15037-R08-A

11 July 2019

Old Granada Studios, Manchester

Stage 4 acoustic design report – zone 6

Zone 6 - GA Plan - Level B1

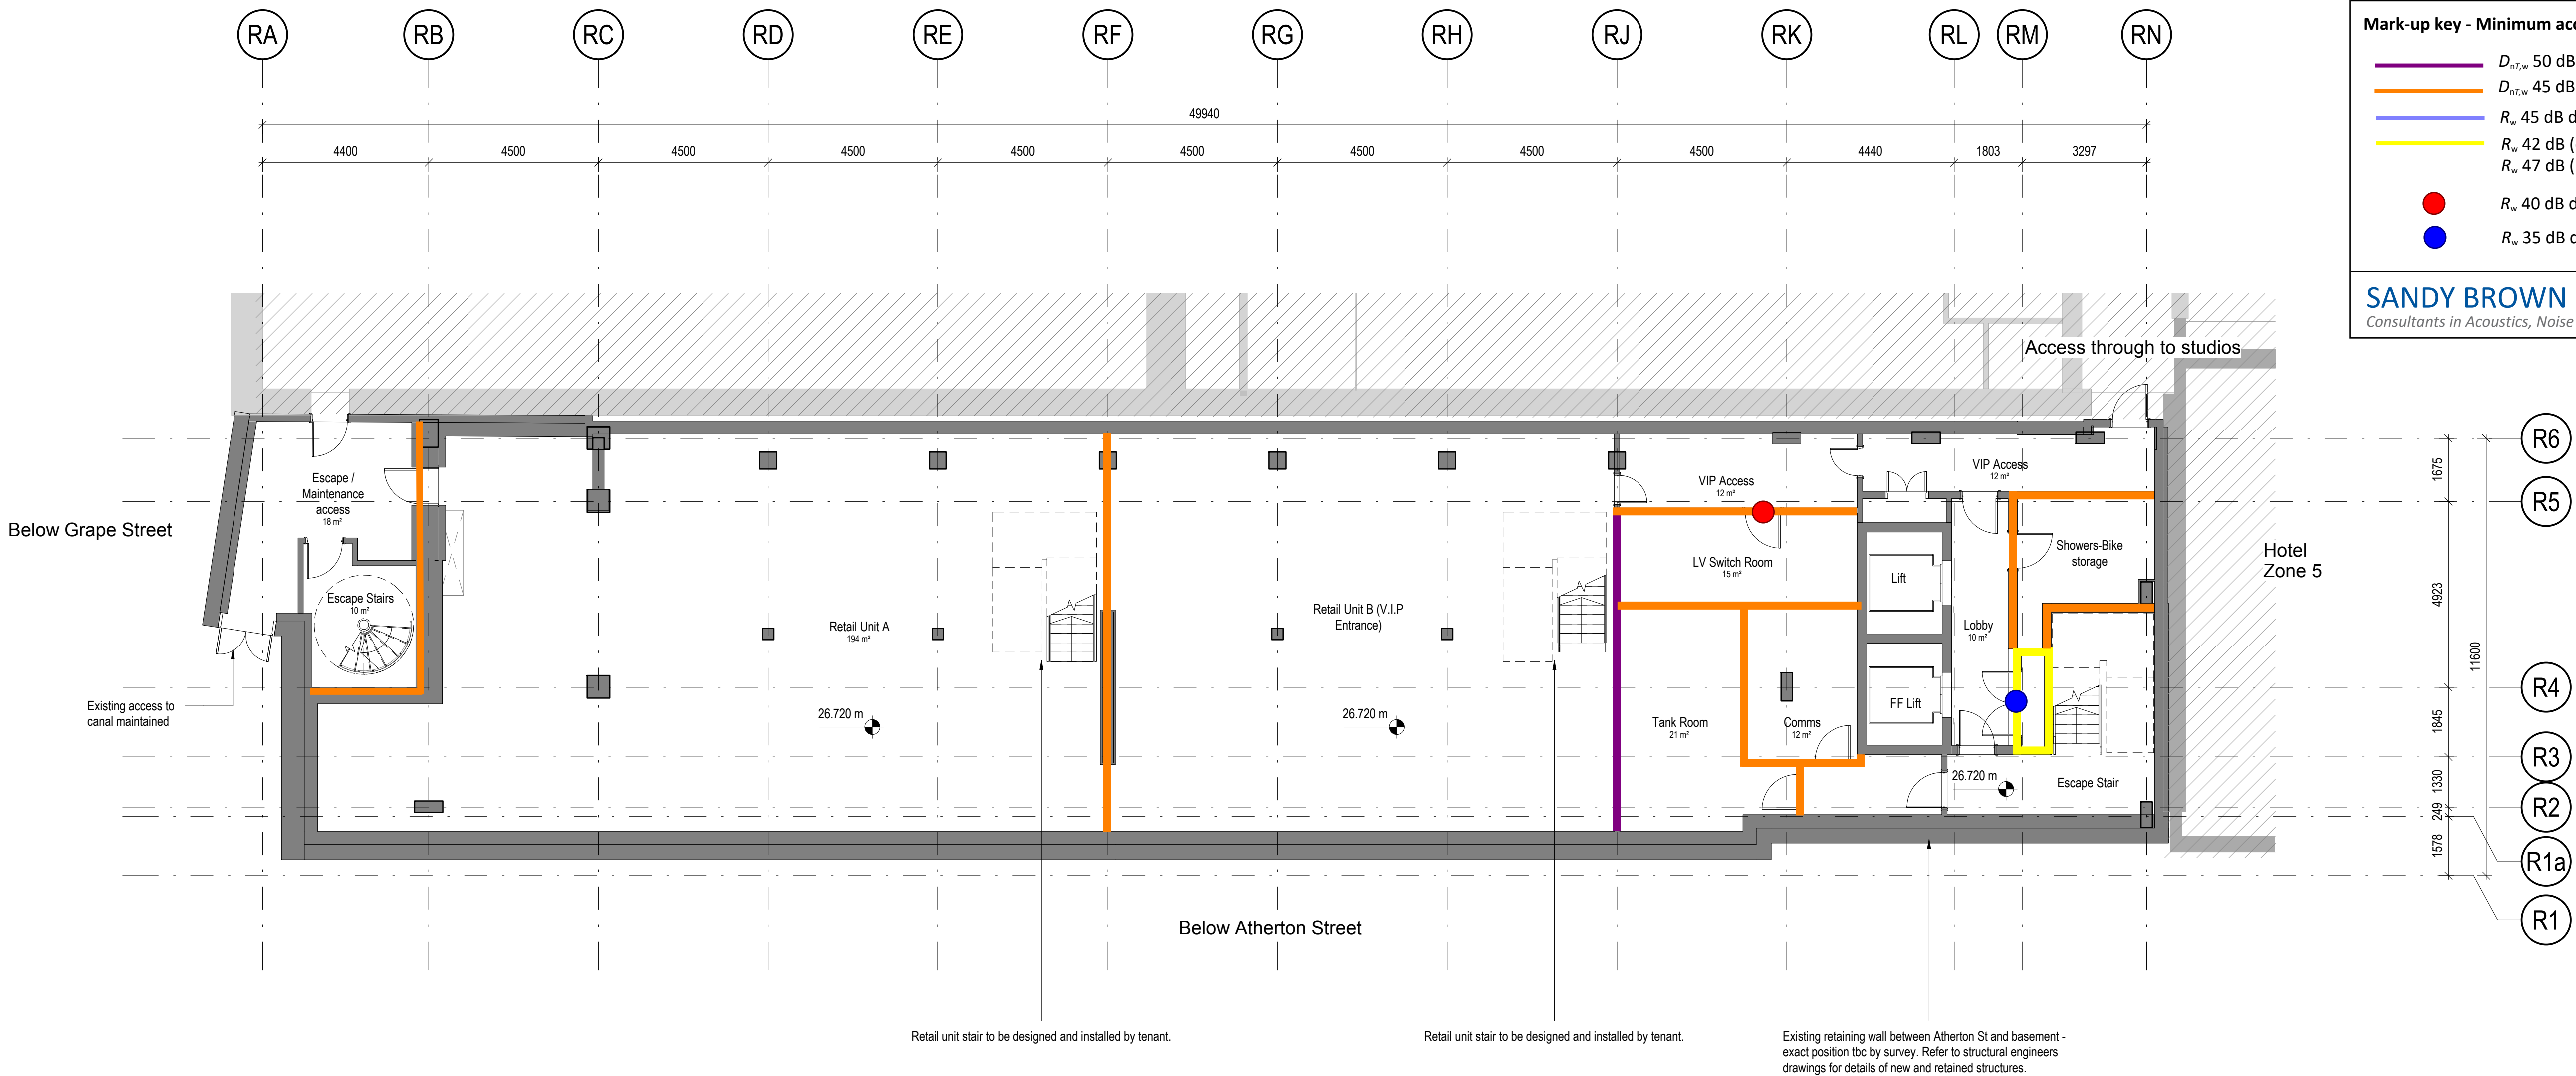
- $D_{nT,w}$ 50 dB partition
- $D_{nT,w}$ 45 dB partition
- R_w 45 dB drywall
- R_w 42 dB (electrical riser)
 R_w 47 dB (mechanical riser)
- R_w 40 dB door
- R_w 35 dB door

Zone 6 - GA Plan - Level 00

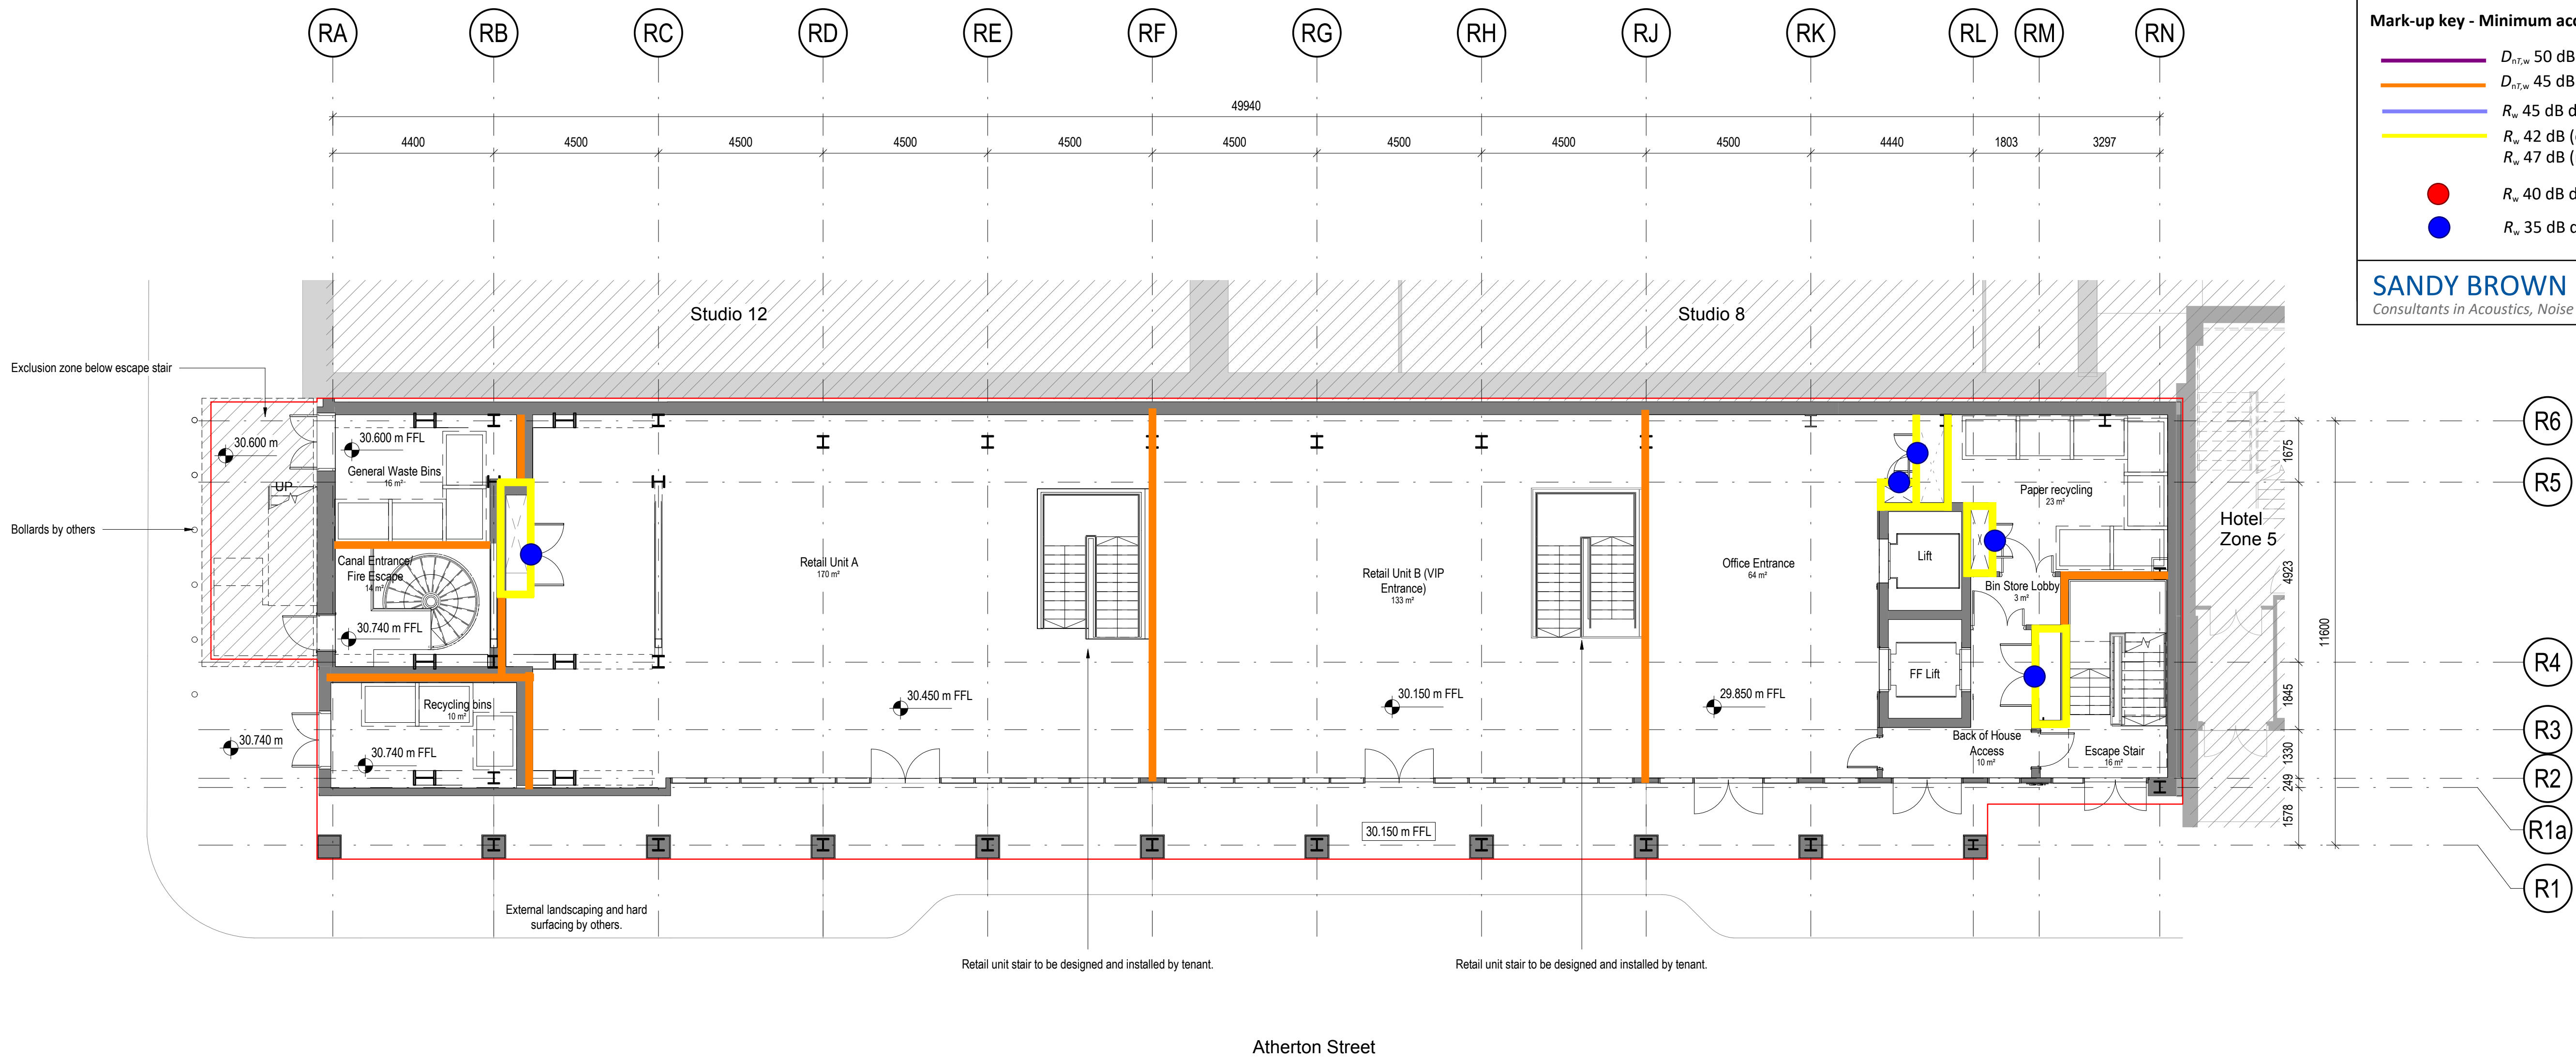
- Mark-up key - Minimum acoustic ratings**
- $D_{nT,w}$ 50 dB partition
 - $D_{nT,w}$ 45 dB partition
 - R_w 45 dB drywall
 - R_w 42 dB (electrical riser)
 R_w 47 dB (mechanical riser)
 - R_w 40 dB door
 - R_w 35 dB door

Zone 6 - GA Plan - Level 01

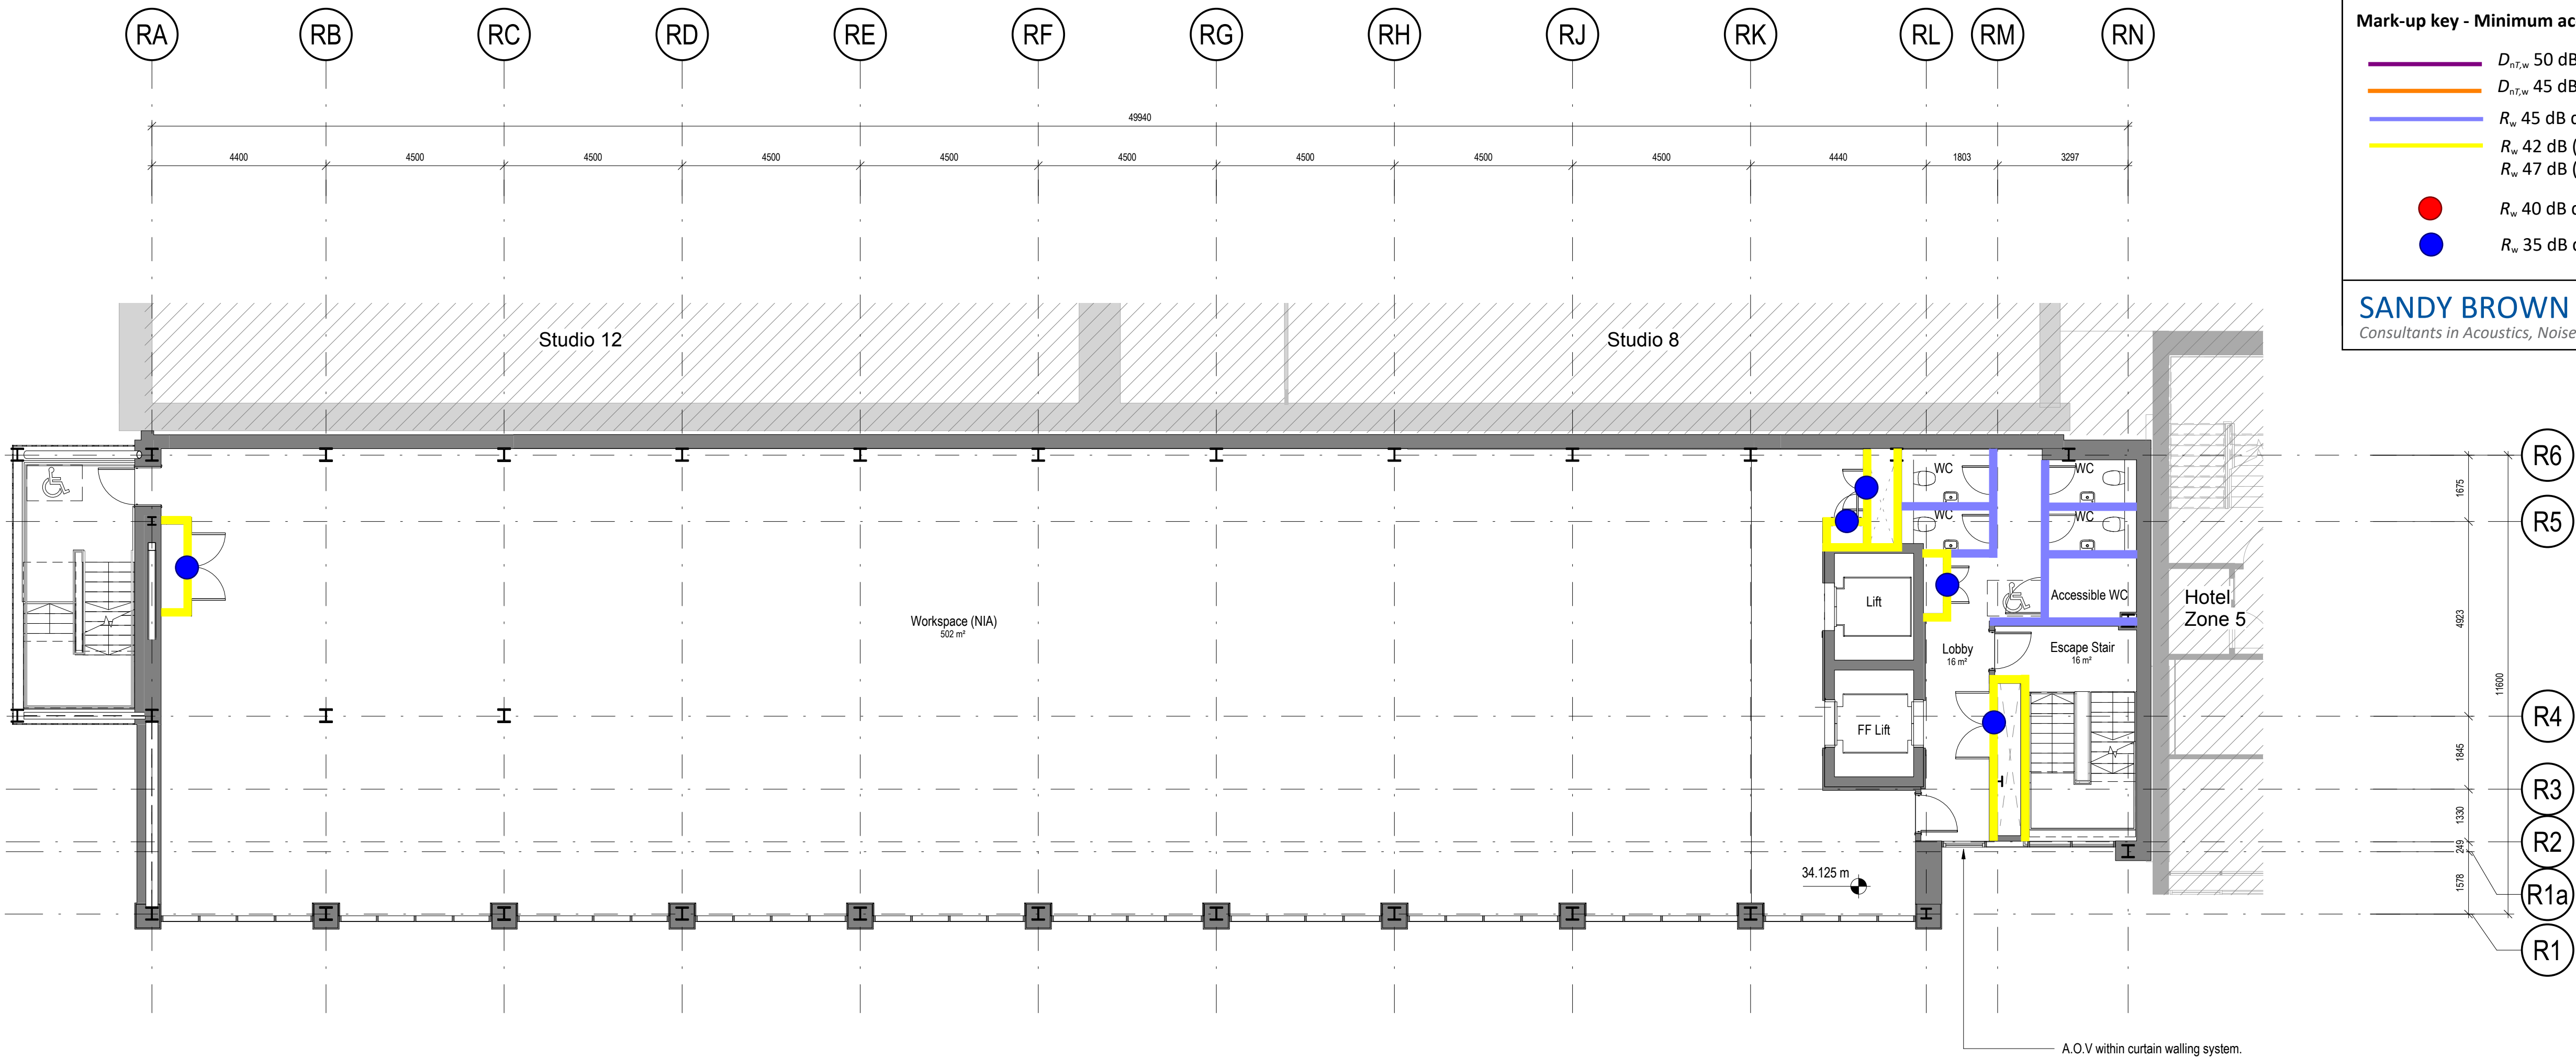
- Mark-up key - Minimum acoustic ratings**
- $D_{nT,w}$ 50 dB partition
 - $D_{nT,w}$ 45 dB partition
 - R_w 45 dB drywall
 - R_w 42 dB (electrical riser)
 R_w 47 dB (mechanical riser)
 - R_w 40 dB door
 - R_w 35 dB door

Zone 6 - GA Plan - Level 02

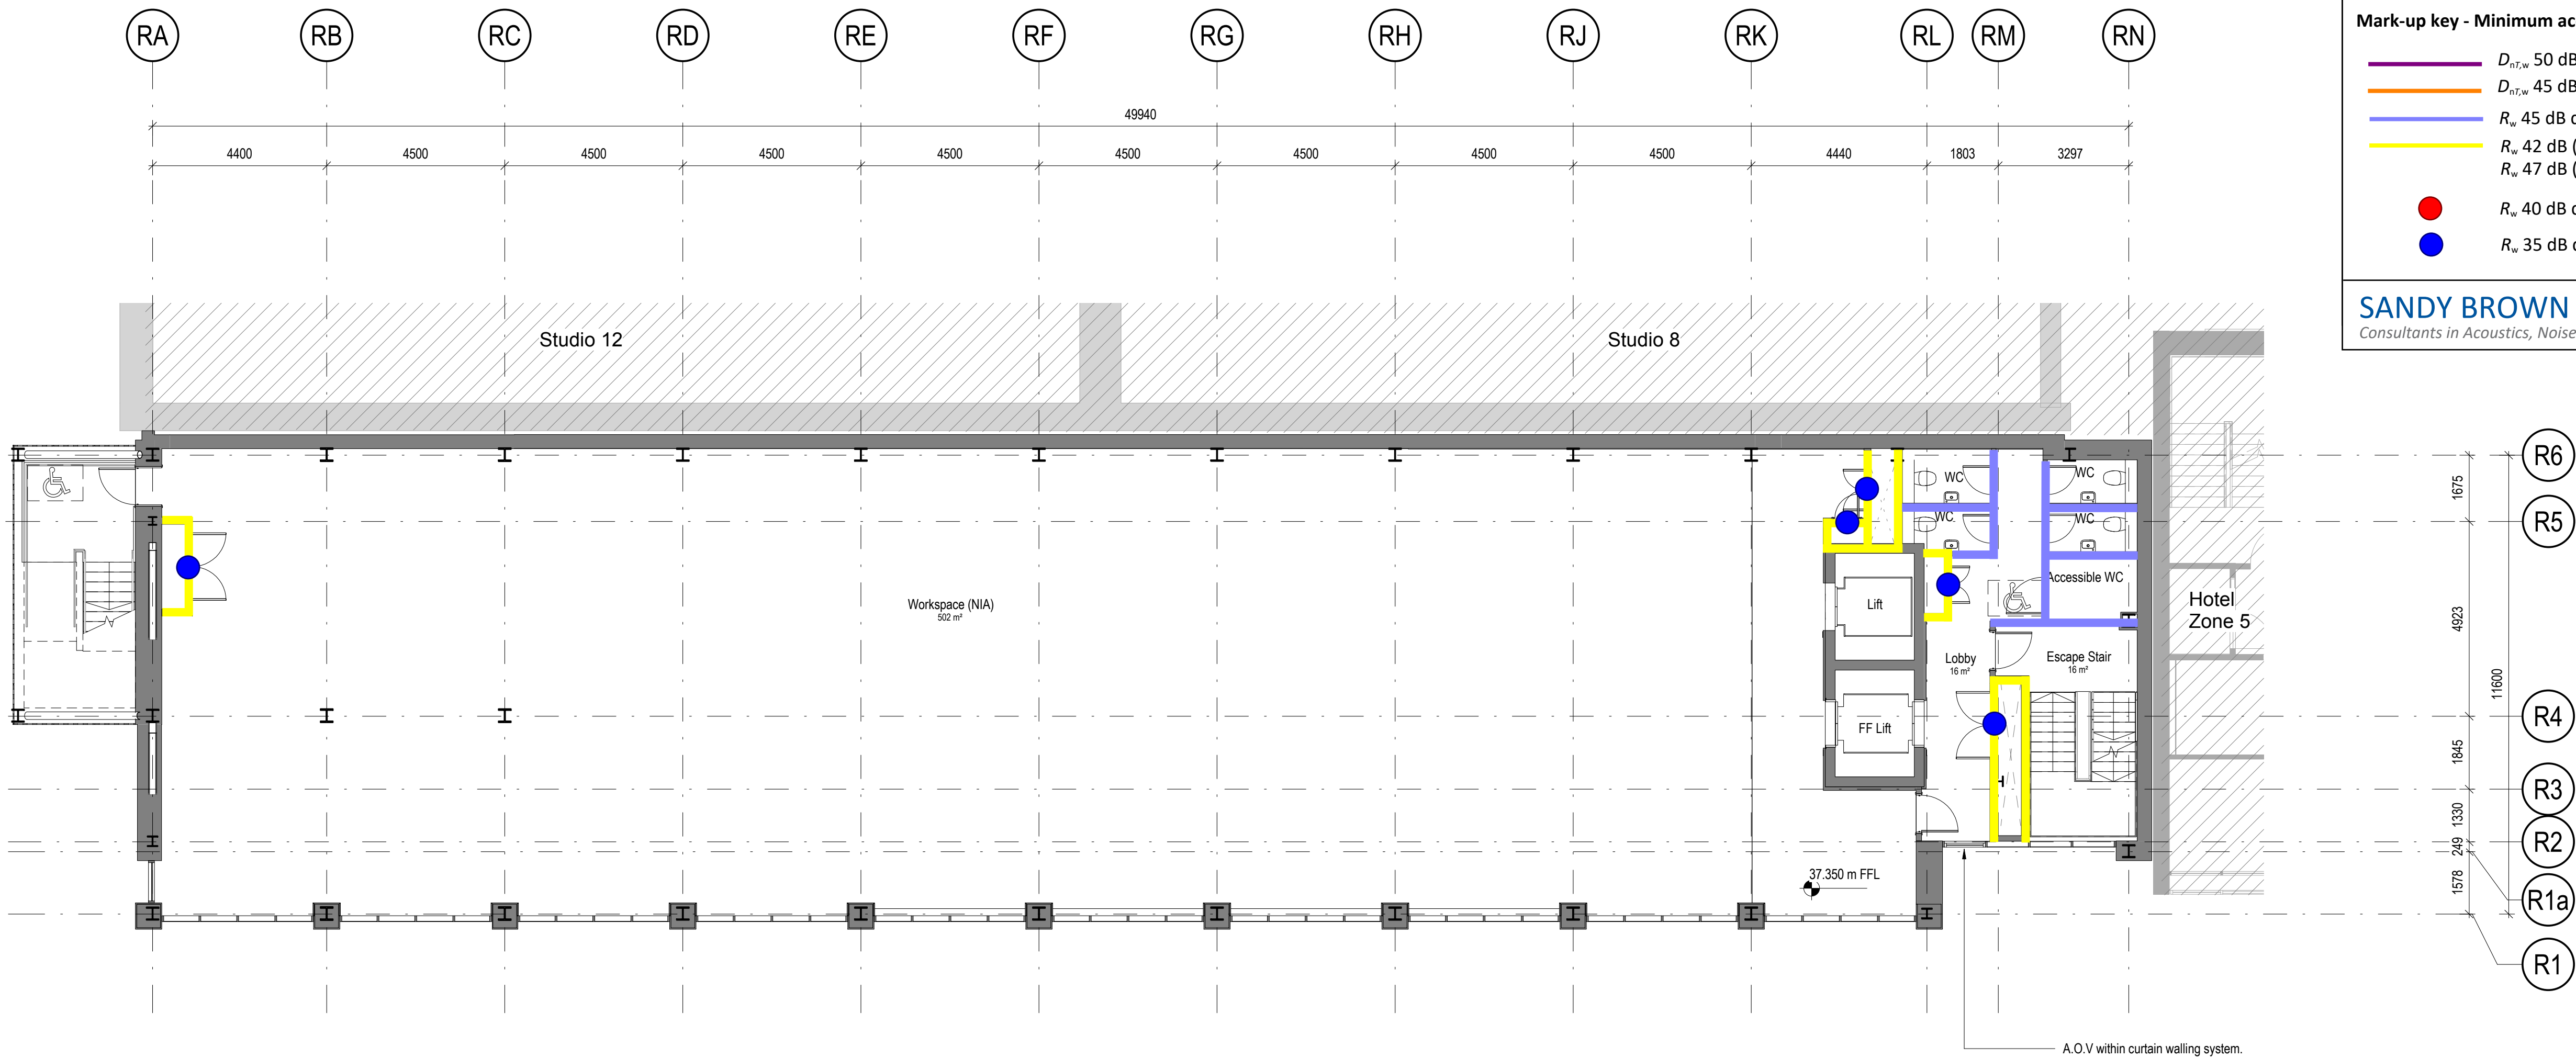
- Mark-up key - Minimum acoustic ratings**
- $D_{nT,w}$ 50 dB partition
 - $D_{nT,w}$ 45 dB partition
 - R_w 45 dB drywall
 - R_w 42 dB (electrical riser)
 R_w 47 dB (mechanical riser)
 - R_w 40 dB door
 - R_w 35 dB door
